## 600 Lonsdale Street

Proposed Design Revisions - Updated Ground Plane 05 March 2020

# **Ground Level Public Interface**

#### **Ground Level Public Interface**

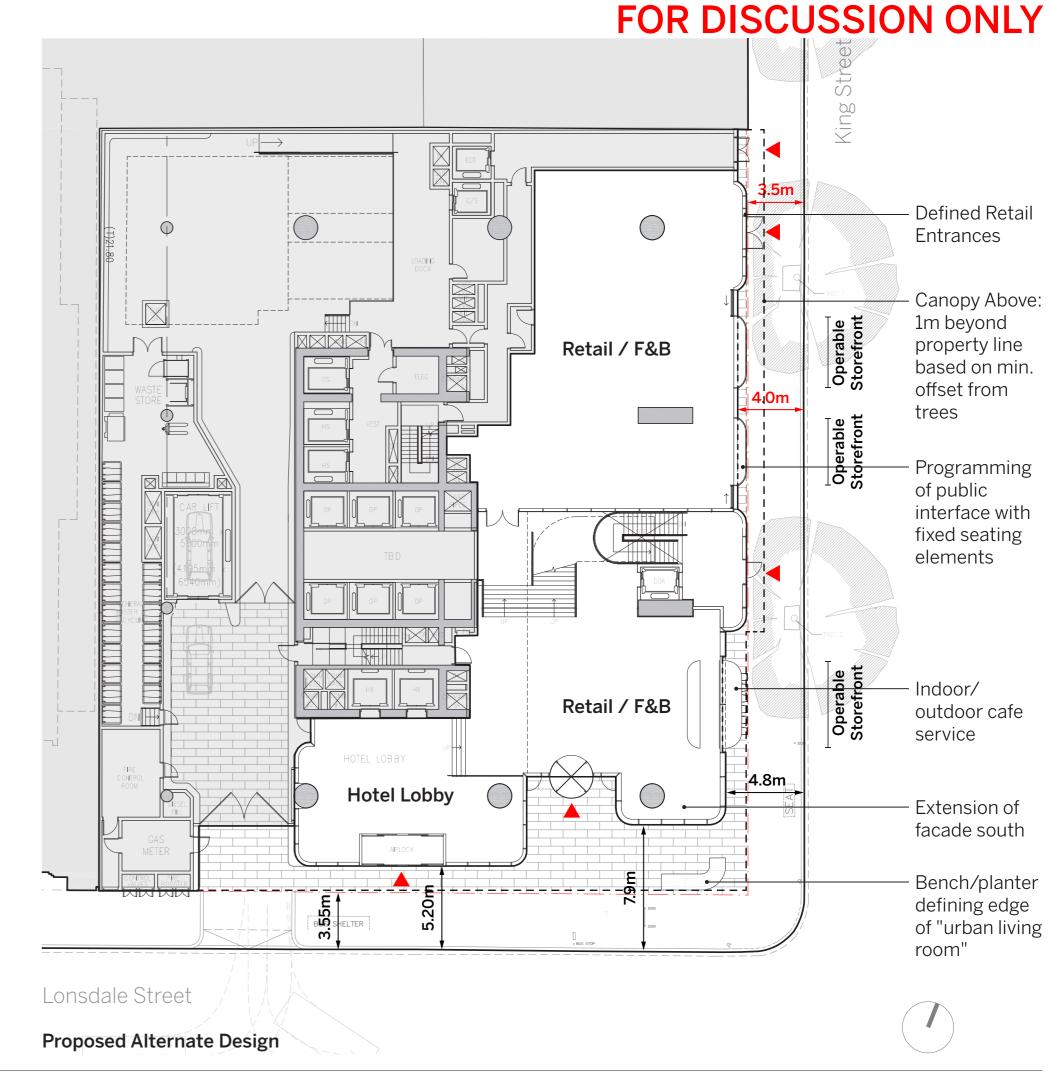
A revised ground floor design and public interface is proposed based on the comments received in the meeting on 16.01.2020:

- Preference for a more balanced approach between solid and open areas at ground level
- More clearly program the use of the recessed space along King Street: define more fixed elements that encourage the use and occupation of the public interface, and ensure the footpath is kept clear for the flow of pedestrians
- Canopy should relate to the rhythm of the facade above, with moments of increased depth to provide pedestrians with variety and choice
- The ground level should more clearly relate to the architecture of the tower above: explore opportunities to introduce landscape and bring the language of solid terracotta volumes and landscaped reveals down to the ground

The ground level has been redesigned in response to the comments received:

- A more varied approach to the King Street retail frontage, with greater play between moments of transparency and opacity defining entrances and moments of activity, with recesses no greater than 500mm
- More defined programming of the public interface on King Street through the provision of fixed elements: indoor/outdoor seating with operable screening for privacy and security
- Re-shaping of the 'urban living room,' extending the activation of the lobby and retail kiosk further south and framing the main office entrance off Lonsdale Street
- Revised extent and design of canopy to better relate to the rhythm of the tower above and provide great variety of coverage and choice
- Integration of landscape elements in the urban living room and at canopy level to bring greenery down to the pedestrian level
